Re: Geotechnical Engineering Services Addendum
Proposed Lot 1 Development
NE Town Center Drive and NE Town Center Blvd
Lee's Summit, Missouri
PSI Project Number: 03382230 Addendum 1

Professional Service Industries, Inc. (PSI), an Intertek Company, is pleased to provide this addendum to the original geotechnical report (Report no. 03382230 dated June 10, 2021) for the above referenced project. The recommendations provided in the original report remain valid.

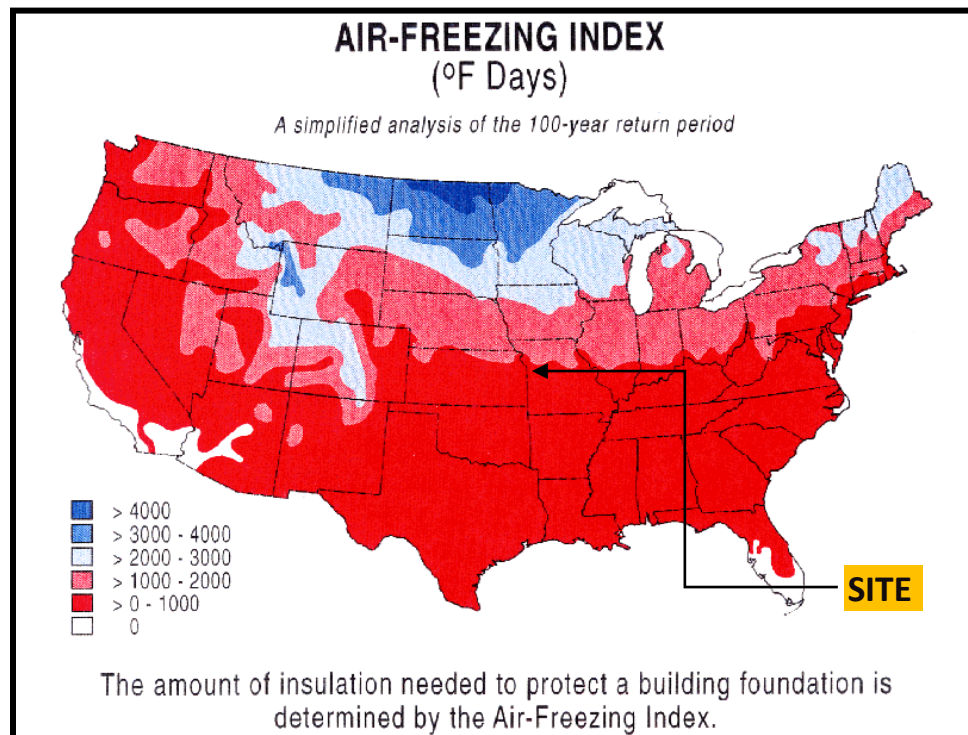
For the project site, the air freezing index from published contour maps in the FPSF design guide is approximately 900° F days. A copy of this contour map is included below. Using this air freezing index, the required insulation values can be found in the FPSF design guide. The R-value of the chosen insulation must consider the long-term moisture for below ground, freezing conditions. For this designation, the insulation values in the table below are required for the dimensions in the figure below:

UNHEATED SLAB RECOMMENDATIONS

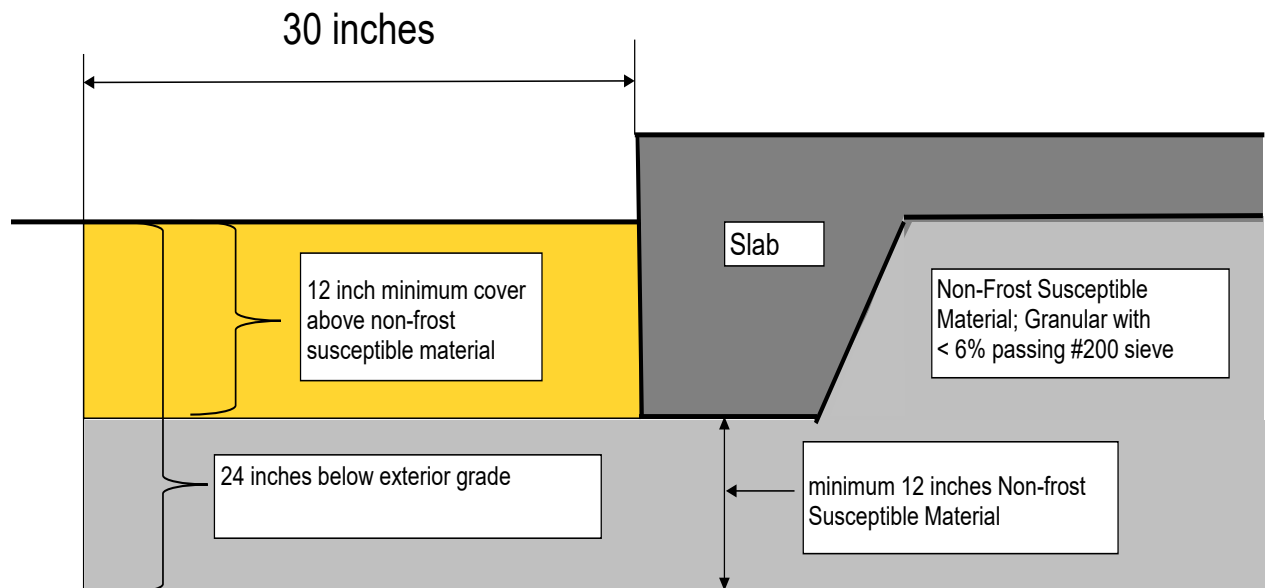
Grade supported slab structures in unheated areas shall have a minimum of 12 inches of non-frost susceptible materials to a depth of 12 inches below the exterior grade with at least 12 inches below the bottom of the slab or perimeter footings. These materials shall extend at least 30 inches from the outside limits of the grade supported slab. The 30-inch dimension can be reduced by 1.25 inches for every additional inch below 12 inches that the non-frost susceptible material is extended below grade. Non-frost susceptible soil is defined as drained, granular material with less than 6% passing the #200 sieve. The non-frost susceptible soils shall be graded, and gravity drained such that it will not impound or trap water within the frost protected area.
